Service Letter No. 404

SUBJECT: Inspection of Altimatic and Altimatic II Pitch Servo Assembly Chain Adjustment Screw

MODELS AFFECTED: PA-23 Apaches, Serials 23-1502 to 23-2046 inclusive
PA-23-250 Aztecs, Serials 27-1 to 27-504 inclusive
PA-23-235 Apaches, Serials 27-505 to 27-572 inclusive
PA-23-250 (6 place) Aztecs, Serials 27-2000 to 27-2388 inclusive
PA-24 and PA-24 "250" Comanches, Serials 24-2003, 24-2203, 24-2299 to 24-3557 inclusive

SERVICE LETTER NO 404

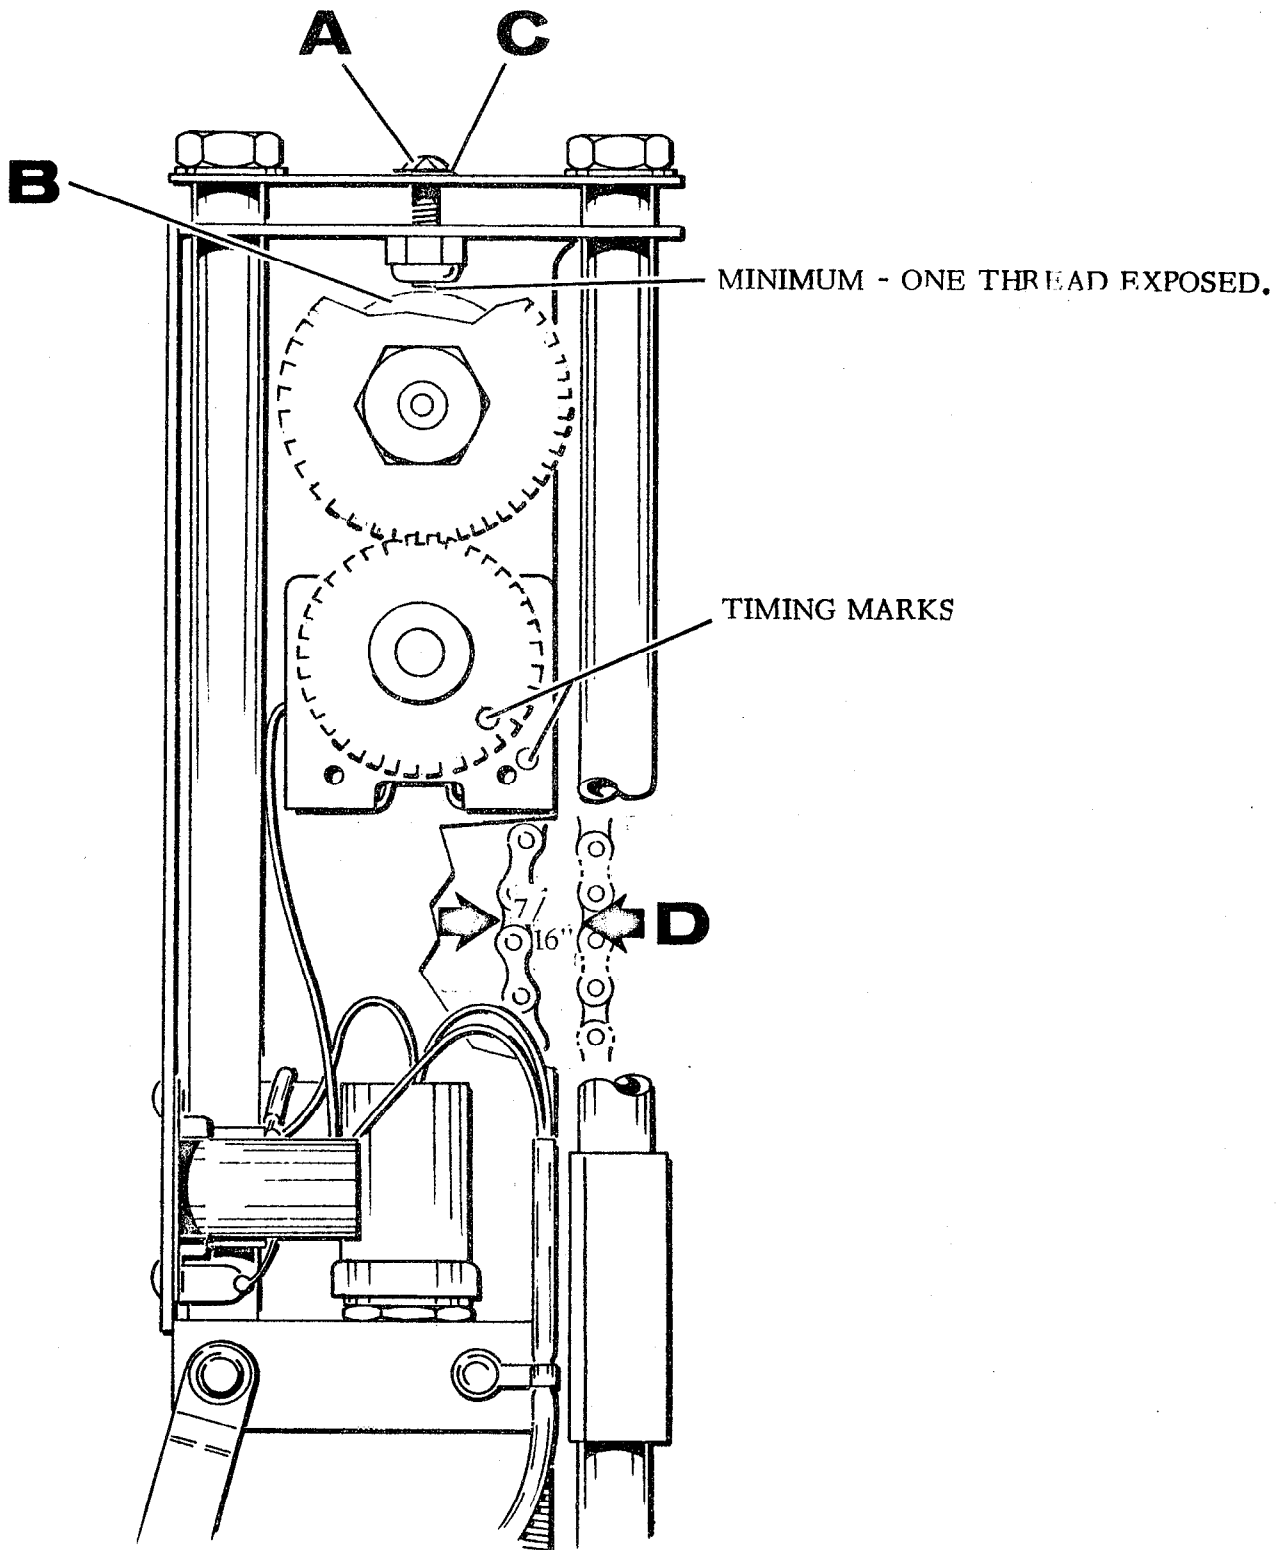
See sketch attached to this letter for screw location and chain adjustment details.

IF LONG-LOK SCREW (A) CONTACTS SPROCKET MOUNTING (B), REMOVE SCREW AND INSTALL PACK WASHERS (C), UNDER HEAD OF SCREW AS REQUIRED TO MAINTAIN CHAIN TENSION OF 7/16" SLACK (D).

In order to provide a positive lock of the screw, at least one or more threads must protrude through the nut. If this cannot be accomplished without maladjustment of the pitch servo chain tension, (See pitch servo chain adjustment procedure on the following page.) it will be necessary to remove the screw and replace it with a "long-lok" type screw (Mitchell part number 3S275). Standard AN 1/32" thickness washers may be used as required under the head of the screw to prevent driving the screw end against the adjacent sprocket mounting.

1. Completely disengage the servo.
2. Measuring on the opposite side of the slide bushing or break-away link in the center of the servo, the chain should have approximately 7/16" slack.
3. By turning the adjusting screw clockwise, the chain tension is increased and by turning counter-clockwise, the chain tension is decreased.
